SUBJECT: Quincy Regional Airport-Baldwin Field
Quincy, Illinois
Adams County
Illinois Project Number: UIN-4332
SBG Project Number: 3-17-SBGP-105
Contract No. QI061
Item No. 6A, July 31, 2015 Letting
Addendum A

NOTICE TO PROSPECTIVE BIDDERS

Revision of construction safety and phasing plans and associated special provisions. Main changes include revision of proposed haul route, addition of some safety provisions and work area notes, and addition of on-site batch plant location.

PROJECT NAME: Realign Taxiway D

CONSTRUCTION SAFETY AND PHASING PLAN- WORK AREA 1

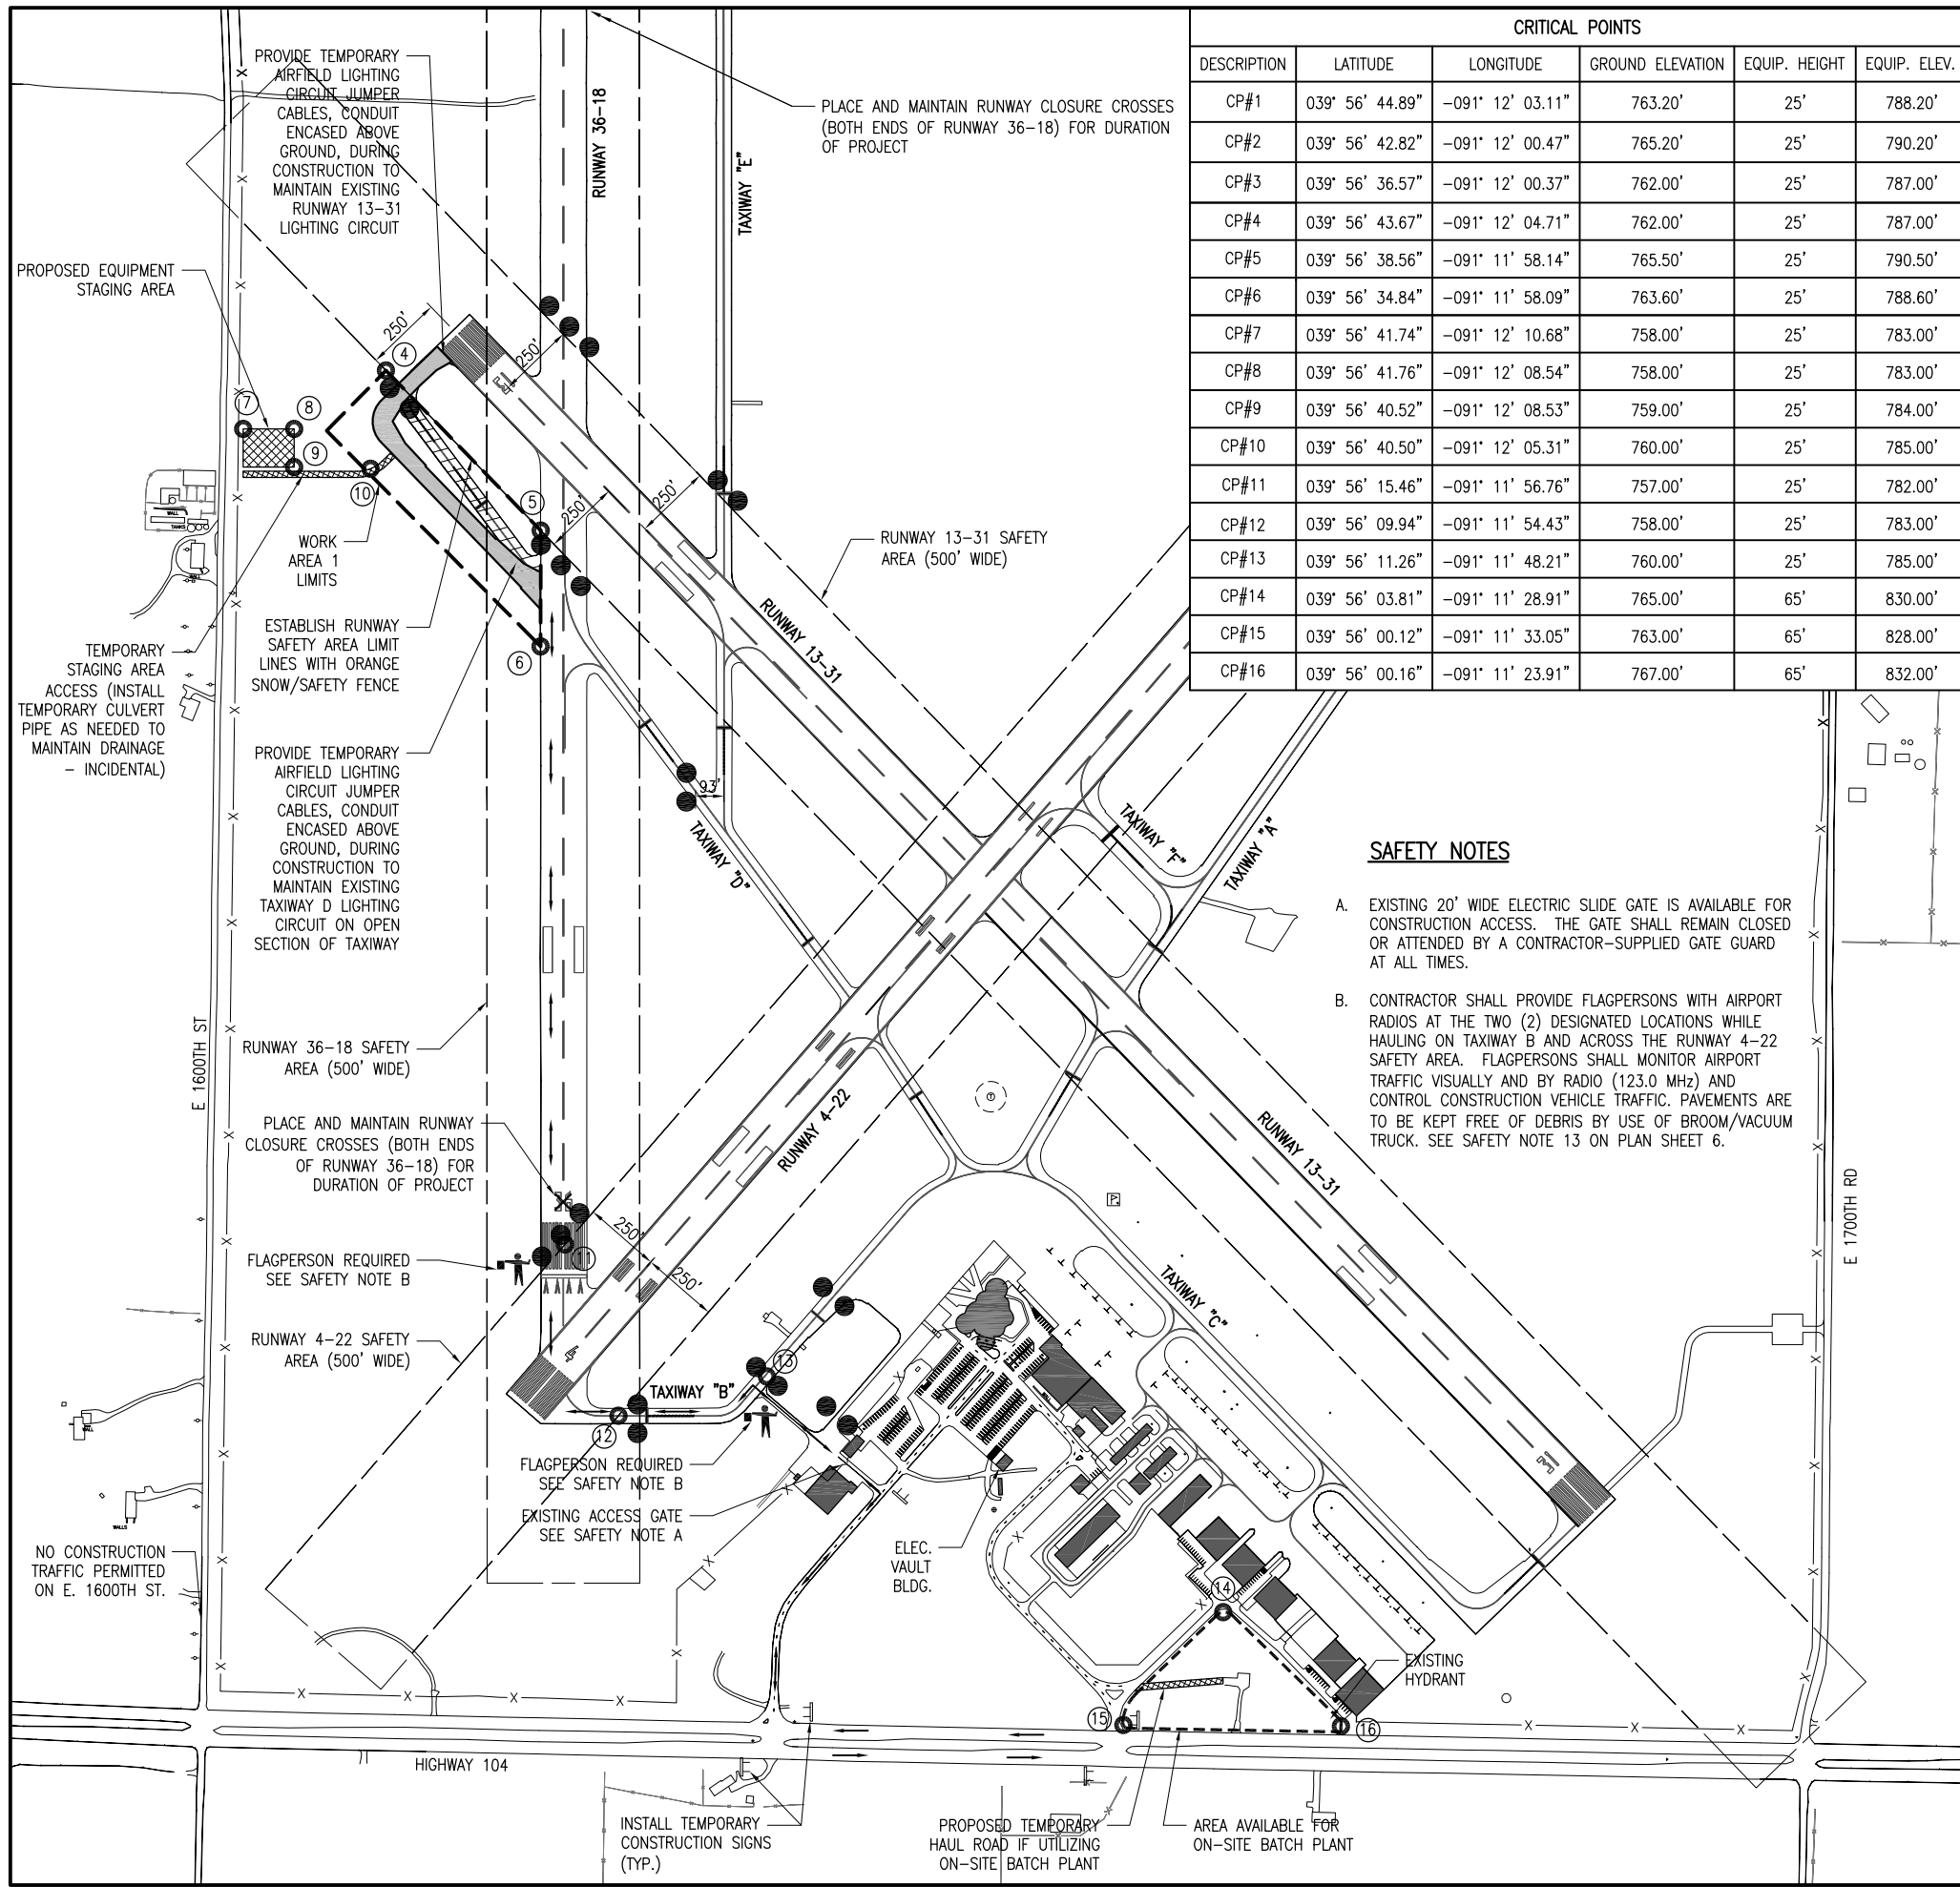
Add: Revised Plan Sheets 4 and 5, dated 07/21/2015. (Attached)
